From: [ELEANOR DUCKETT](#)
To: [MCP-Chair](#)
Cc: [Marc Elrich](#)
Subject: Wheaton Gateway Planning Board Hearing 11-20-2025
Date: Monday, November 17, 2025 4:36:48 PM
Attachments: [FINAL Wheaton Gateway Planning Board Hearing 11-20-2025 , 11-17-2025 comments.docx](#)
[Attachment A Book 4, Plat 303 Kensington View Sections 1 & 2 MSA S1249 8116.pdf](#)
[Kensington View Dead-ends Attachment B.png](#)
[Attachment C Kens. Blvd. Veirs Mill Intersection.png](#)
[Attachment D 16-TURN-820240150-001.pdf](#)
[Attachment E - East Ave. Traffic 4-23-2021.png](#)
[Attachment F Wheaton Gateway Plan Review Questions 3-27-2025 SHA Responses - 05162025 \(2\).docx](#)

Re: **Wheaton Gateway Preliminary Plan No. 120240120**

The Kensington View Civic Association respectfully request that the Planning Board deny or, at a minimum, require further traffic studies prior to the approval of the Wheaton Gateway Preliminary Plan No. 120240120, Sketch Plan Amendment and Site Plan No. 820240150 & Forest Conservation Plan No. F20240810.

SECTION ONE
KENSINGTON VIEW
MONTGOMERY CO., MARYLAND

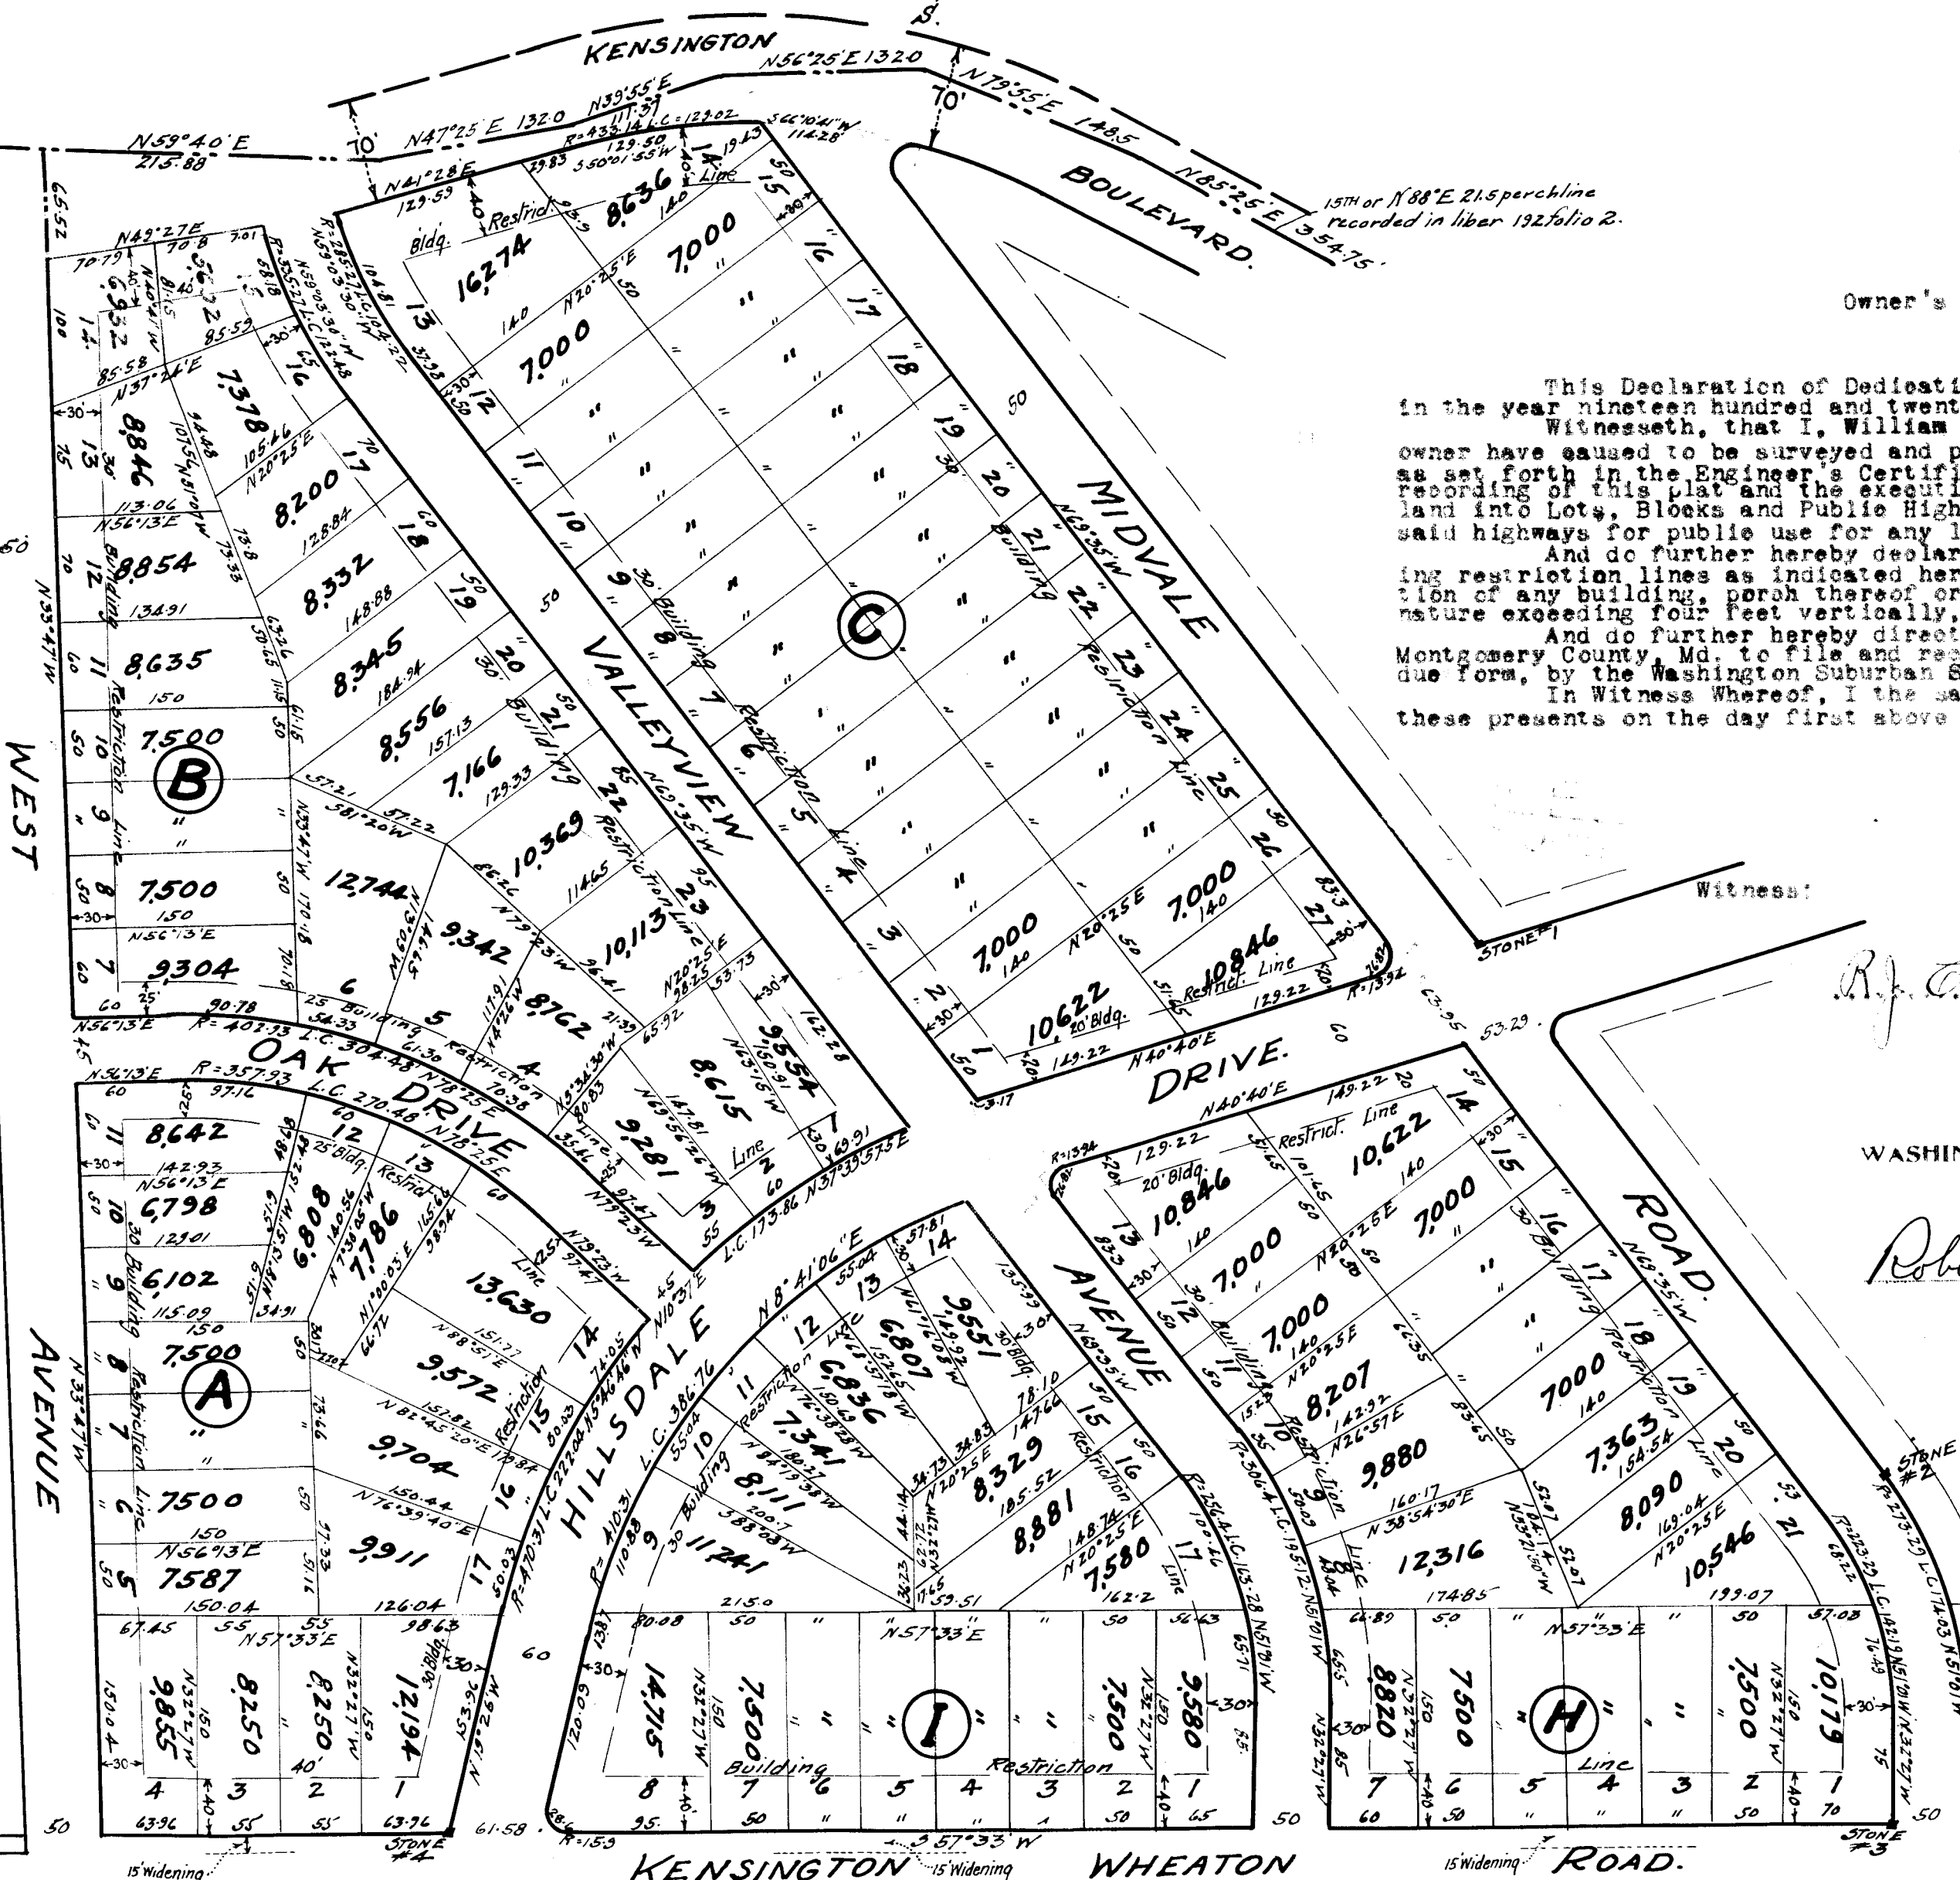
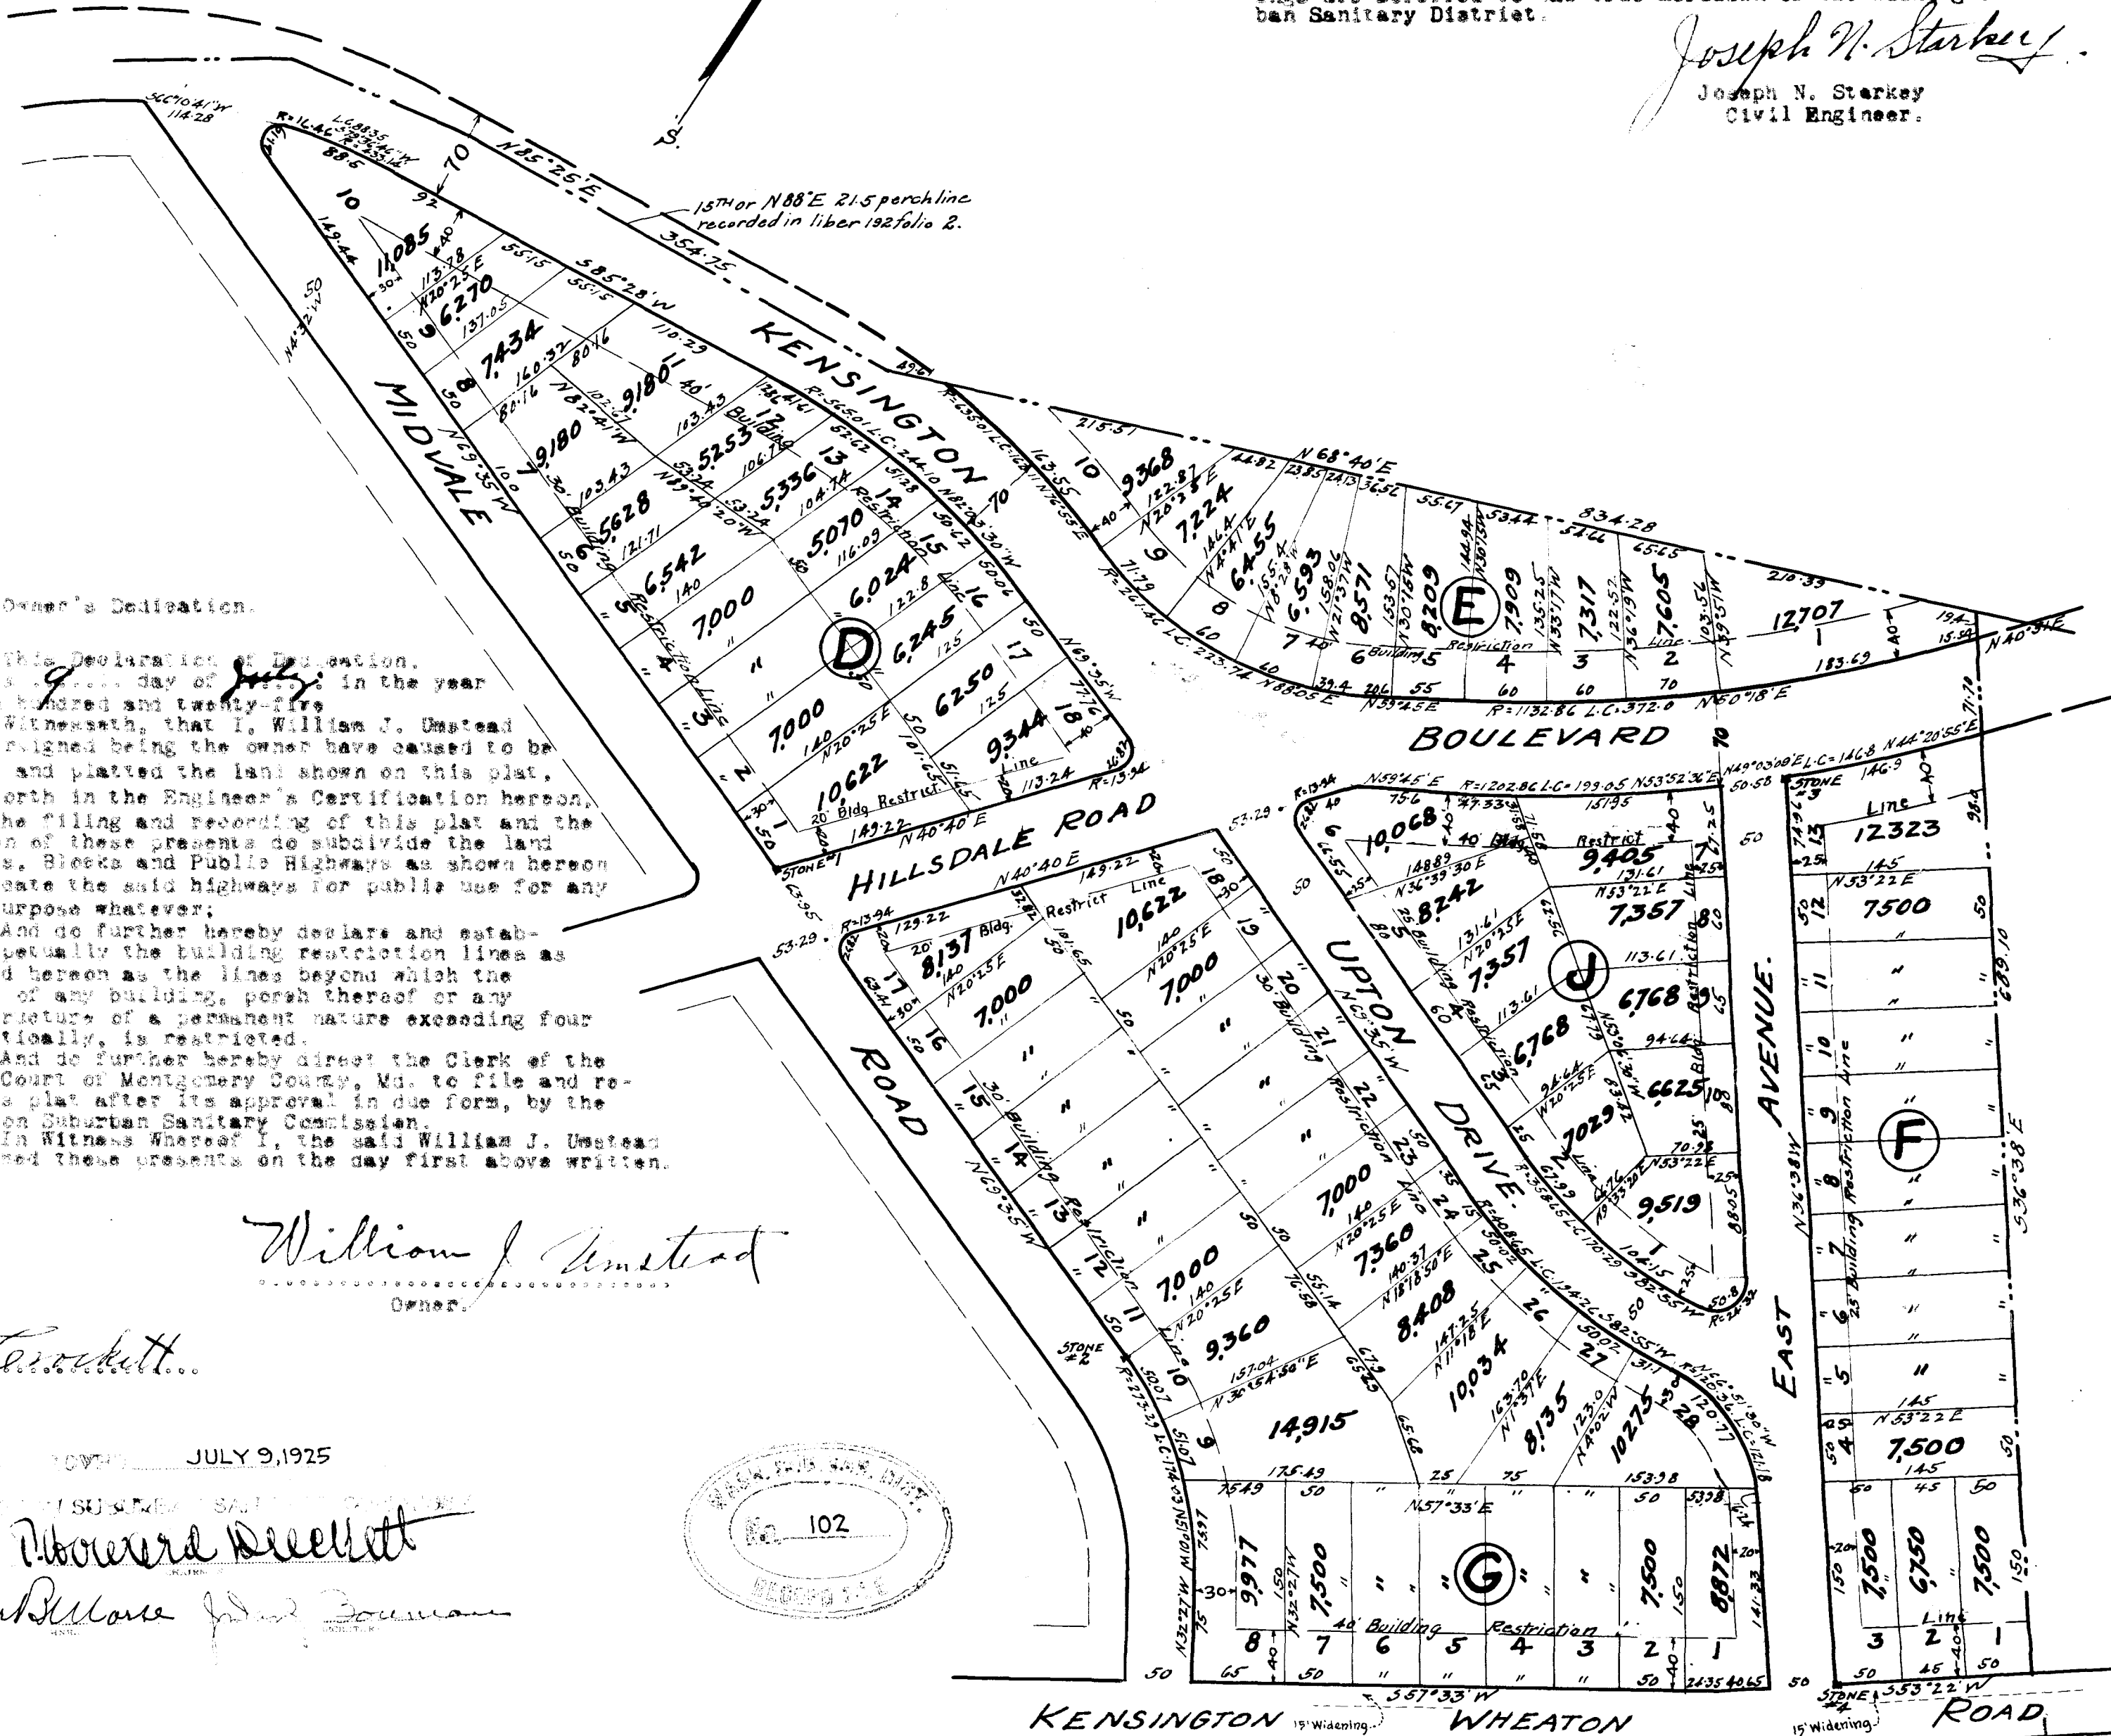
The Kensington View Subdivision (Section One and Section Two) was subdivided and recorded in 1925. The original subdivision had a street pattern that supported the Kensington View subdivision, with a 70' Kensington Boulevard platted as a primary boulevard acting as a ring road that ran from Wheaton to Kensington. (Attachment A)

Due to the Kensington Branch Silver Creek and elevations, many roads were never built by the County. We now have Section Two, Kensington View Subdivision completely separated from Section One with multiple dead-end streets that terminate at County owned properties (Crossway's/former Pleasant View Elementary School, Pleasant View Park, Albert Einstein High School). There are only two entrances/exits from University Boulevard that allow ingress/egress for residents. One is a signalized intersection at East Avenue (platted at 50', built to 22.1'; not 60' that the Planner's state on page 44 of their submission) and the other is a right-turn only exit from Midvale Road (platted at 50'). Midvale Road has a line-of-sight problem when exiting onto University Blvd. East Avenue is a primary residential street that is platted at tertiary road standards with no proposed upgrades. Homes on Kensington Blvd. can only be accessed via East Avenue. These dead-end roads cannot support the traffic proposed by the Wheaton Gateway Plan's traffic circulation plan. (Attachment B)

**RIGHT
TURN
ONLY**

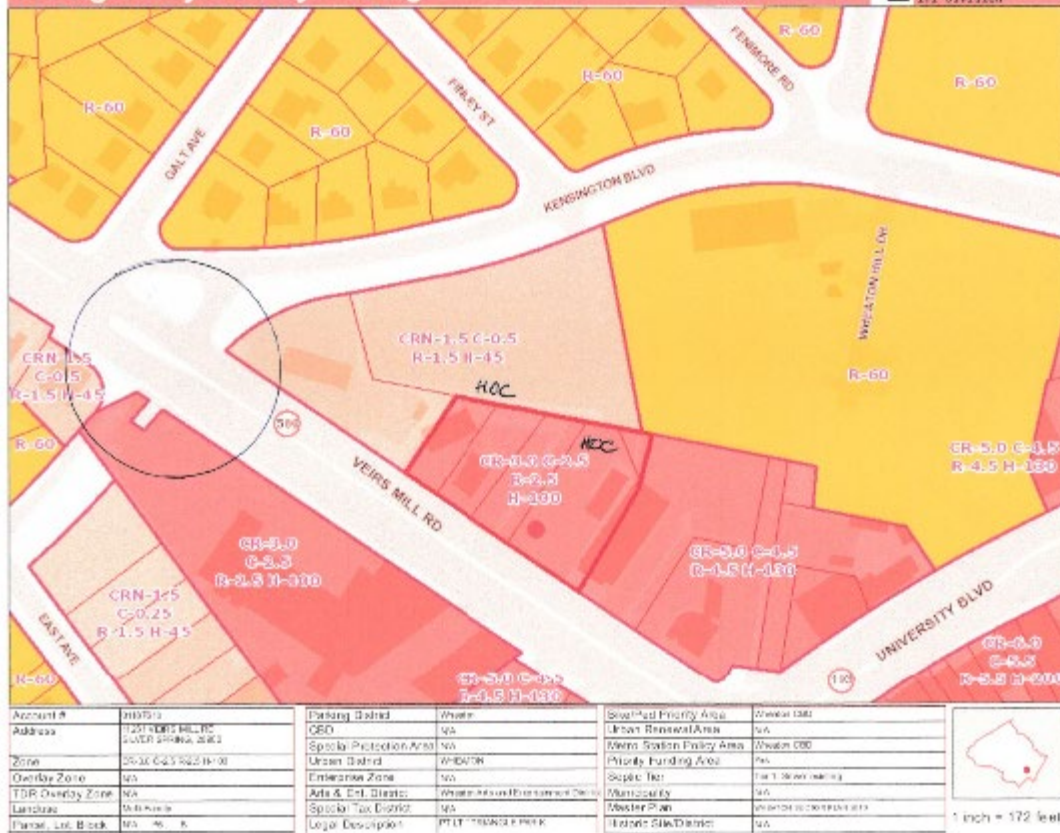
From a personal experience this morning, I am not sure large trucks will be able to enter East Avenue travelling east or west bound from University Blvd. I had a doctor's appointment on Georgia Avenue and was sitting on East Avenue at the light in the one lane that allows vehicles to make a left hand turn onto University Blvd. (Midvale Road does not allow left hand turns). A car carrier truck travelling westbound on University Blvd. was trying to make the right-hand turn onto East Avenue. In order to allow the truck to make the right-hand turn, I had to back up three car lengths. Luckily, there were no cars behind me. While car carrier trucks may disappear when Lindsay vacates, we question how any large trucks will be able to turn onto East Avenue from University Blvd.

The Planner's submission regarding East Avenue does not include a photo of the stacking room from the Upton Drive/East Avenue merge to the light at University Boulevard. The photo we are submitting shows the traffic (mainly from McDonald's two exits adjacent to the proposed internal road) that backs up periodically at the light at University Boulevard. East Avenue has one ingress lane, one egress lane (straight or left turn movement) and one right-turn only egress lane. Additional traffic exiting the proposed development, especially large trucks, could severely impact this intersection and limit access to homes and facilities on Kensington Blvd., Upton Drive, Hillsdale Drive and Midvale Road. (Attachment E)
